ADDENDUM NO. 3
TO THE BID DOCUMENTS
FOR THE
ATCT RENOVATIONS PHASE II- GLASS REPLACEMENT
BOCA RATON AIRPORT
BOCA RATON, FLORIDA

November 1, 2018

Addendum #3 – Bidder's Questions

Outer Panel 1/4" glass / 0.060" SentryGlas / 1/4" glass
Low e Applied to the inside (air space side) surface of outer panel
Air Space 1/2" with capillary tube
Inner Panel 1/4" glass / 0.060" SentryGlas / 1/4" glass
Total Nominal Thickness 1 5/8" LIGU thickness

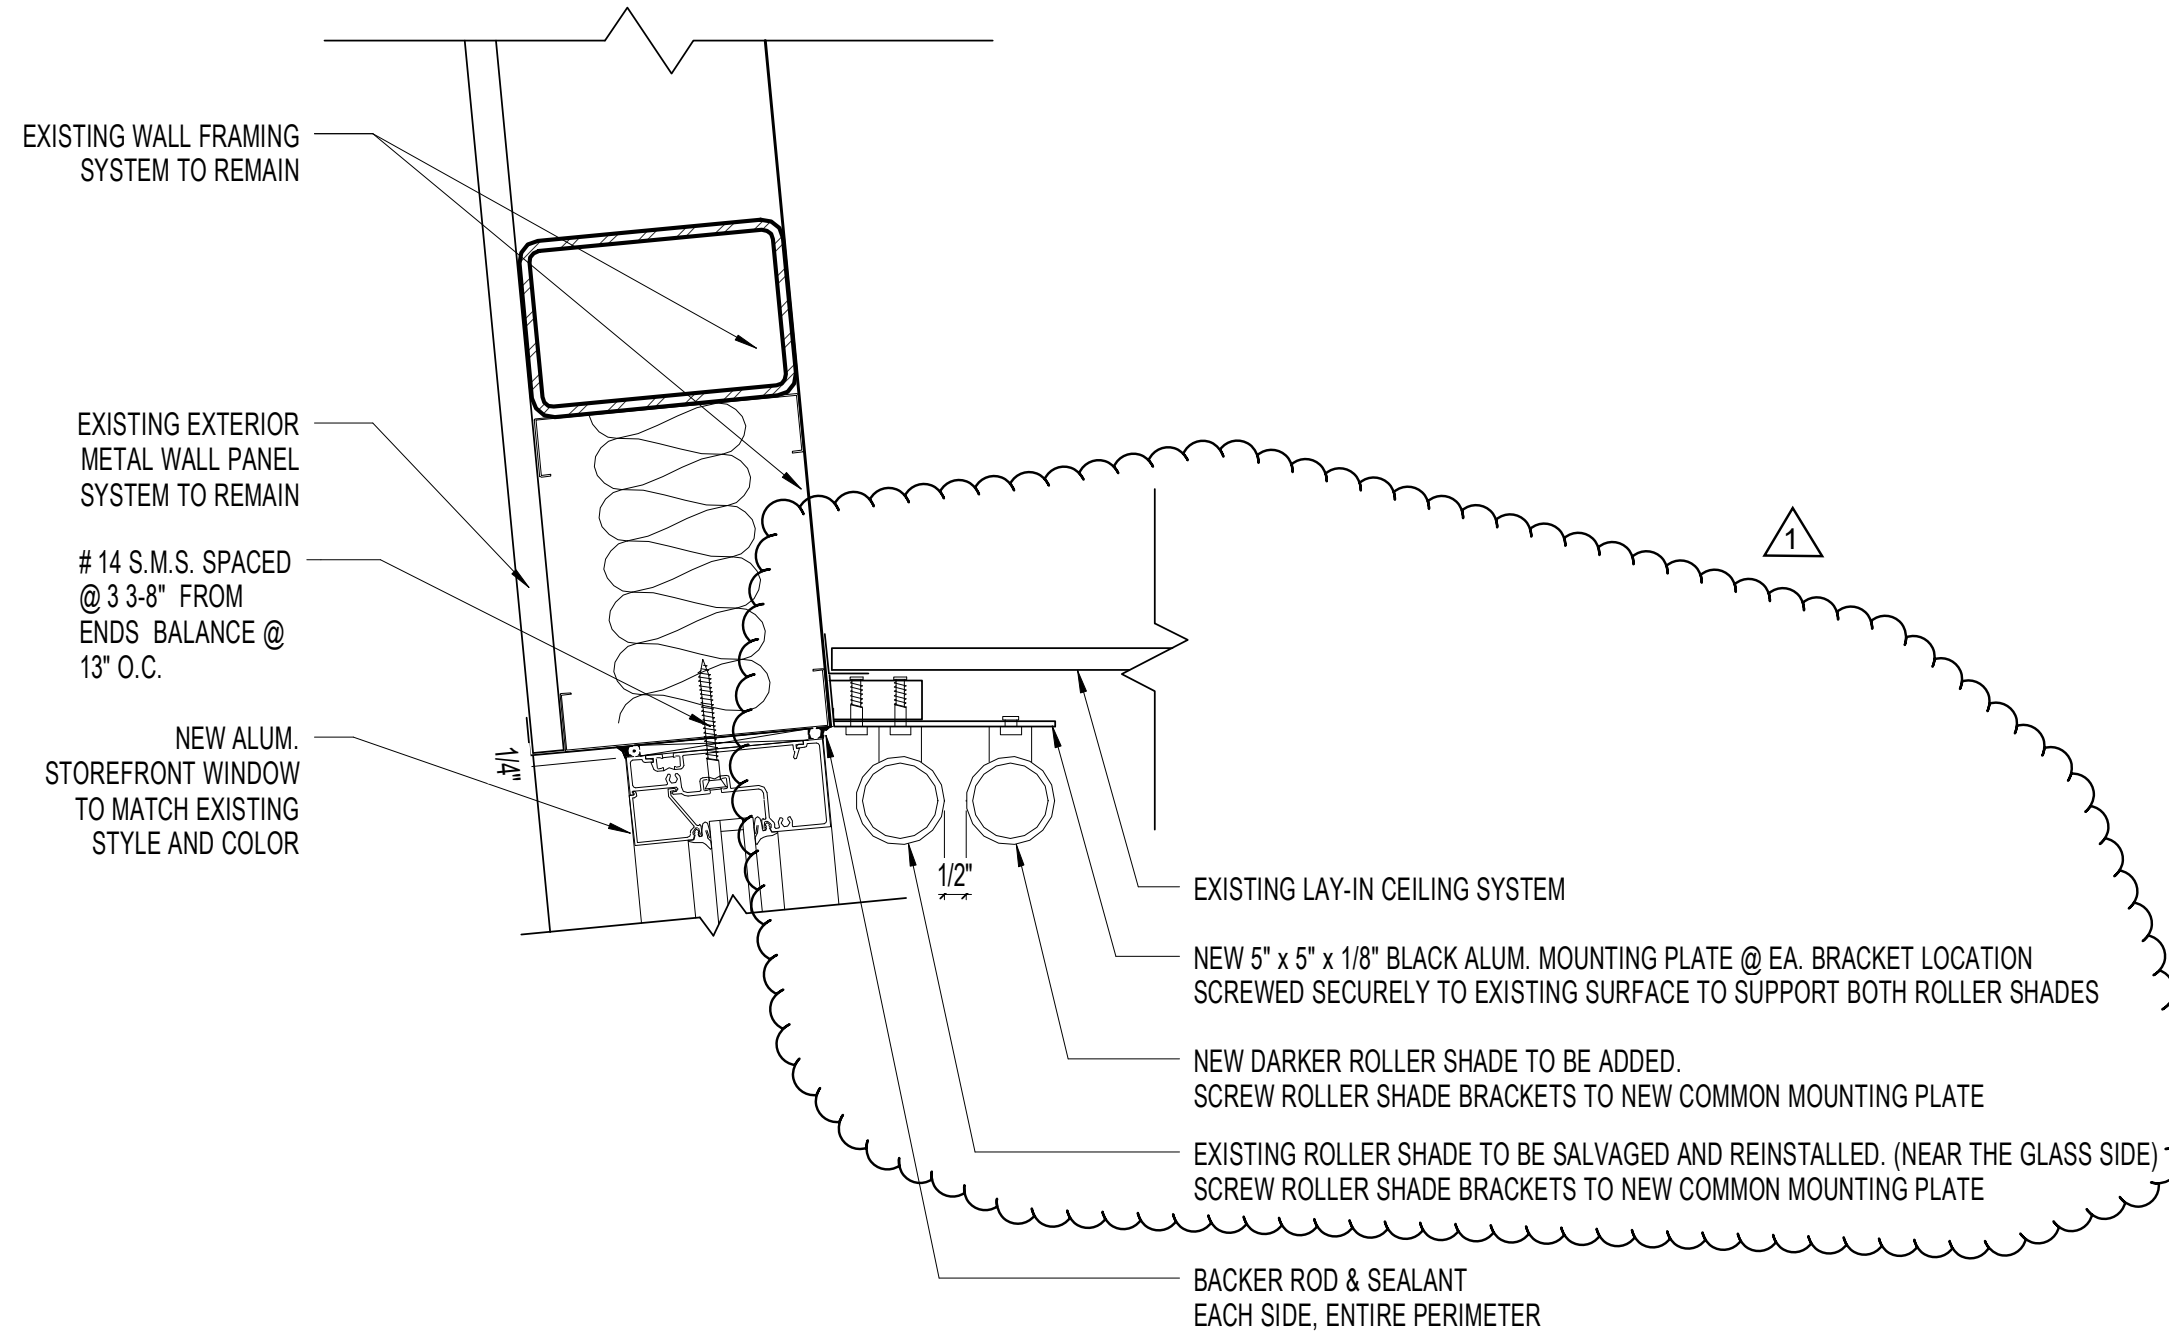
Q5: The one supplier we have contacted will provide the Low-E, however, they will not warranty the glass to pass the "L" test. Please advise.

A: The glass needs to be warrantied to pass the "L" test. If the supplier is concerned with which side of the Laminated Insulated Glass Unit (LIGU) glazing the low e coating is being applied, the design intent is to NOT apply the low e coating on the same surface as the SentryGlas. The low e coating shall be installed on the inside of the outer panel that is facing the 1/2" air space. Revise Spec 08 80 10, paragraph 2.02.E to the following (change is underlined).
